PARTS & SERVICE NEWS

REF NO. AA00142

SUBJECT: CORRECTION OF FUSE BOXES IN OPERATORS CAB

APPLICATION: HD325-6 Dump Trucks, S/N 5292
HD785-3 Dump Trucks, S/N 2269 thru 2276, 2278 thru 2283, 2290 and 2291
HD785-5 Dump Trucks, S/N A10228 and up
330M Dump Trucks, S/N Cf24120 and up

Fig. 1

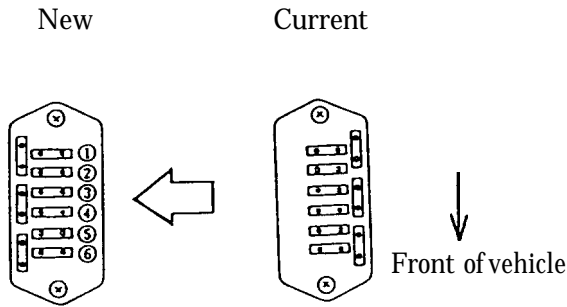
The fuses in the fuse box in the operator's cab may be installed different from those indicated on the nameplate. In this case, rectify them according to this **PARTS & SERVICE NEWS**.

- (1) Open the rear cover in the operator's cab.
- (2) Remove the two mounting screws of fuse box A (BT3), and reinstall it inversely (Fig. 1 and Fig. 2).

- (3) After inverting fuse box A, exchange fuses ② and ⑤ with each other.

New	Current
② : 20A	10A
⑤ : 10A	20A

Fig. 3

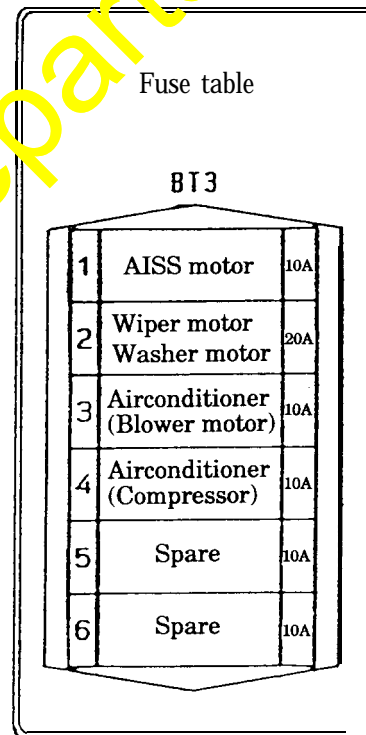
Confirm that the capacity of each fuse in fuse box A now conforms to that on the fuse nameplate (Fig. 3) stuck to the back of the rear cover.
